Access Compliance Report

Public Rights-of-Way

(Curb Ramps)

Intersection ID: 29343	Main Street: ELIZABETH_RD	Cross Street: BIRCHSTONE_LN	Location:	N
ADA ID: B1442B12842F	Ramp Type: BlendTrans1	Initial Pass/Fail: Fail	Overall Compliance: No	Severity Score: 33.75

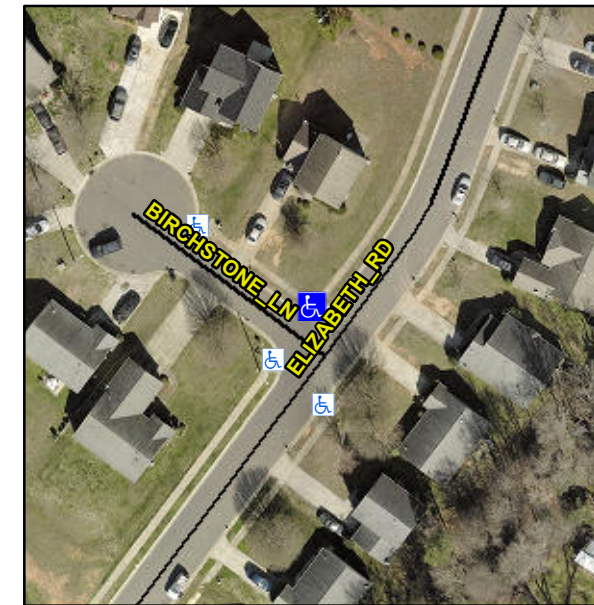
Not Found, R304.5.1, R304.5.3

Compliance	Description	Data	Compliance	Description	Data
N/A	Ramp Length (in)	47.0	Yes	BlendTrans Slope (%)	2.8
No	Ramp Width (in)	42.0	No	BlendTrans XSlope (%)	7.3
N/A	Flare Type LT	N/A	N/A	Flare Type RT	N/A
N/A	Flare Slope LT (%)	N/A	N/A	Flare Slope RT (%)	N/A
N/A	Flare Traversable LT?	N/A	N/A	Flare Traversable RT?	N/A
N/A	Landing Length (in)	N/A	N/A	DWS Provided?	N/A
N/A	Landing Width (in)	N/A	N/A	DWS Contrast?	N/A
N/A	Landing Slope (%)	N/A	N/A	DWS Length (in)	N/A
N/A	Landing X Slope (%)	N/A	N/A	DWS Full Width?	N/A
N/A	Landing Curb? (Y/N)	N/A	N/A	DWS Offset (in)	N/A
N/A	Shared Landing?	N/A			
N/A	Gutter Ponding?	N/A	N/A	Gutter Slope (%)	N/A
N/A	Gutter Lip Ht (in)	N/A	N/A	Gutter X Slope (%)	N/A
N/A	Painted X Walk1?	No	N/A	Painted X Walk2?	No
	X Walk 1 Direction	To SW		X Walk 2 Direction	To SE
	X Walk 1 Width (in)	N/A		X Walk 2 Width (in)	N/A
	X Walk 1 Slope (%)	0.3		X Walk 2 Slope (%)	5.3
	X Walk 1 X Slope (%)	7.4		X Walk 2 X Slope (%)	2.1

N/A	Ramp inside XWalk1?	N/A	N/A	Ramp inside XWalk2?	N/A
	Road Slope (%)	7.0		Clear Space?	N/A
	Road X Slope (%)	3.1	N/A	Clear Space to XWalk (in)	N/A
N/A	Any Obstructions?	N/A	N/A	Storm Grate/Utility Hazard?	N/A
	Obstruction Type			Storm Grate/Utility Type	
		N/A			N/A
			Yes	Surface Condition? (G/P)	Good
			No	Curb Slope (%)	16.6

Remove & Replace Curb Ramp With Two New Directional Ramps or Equivalent.
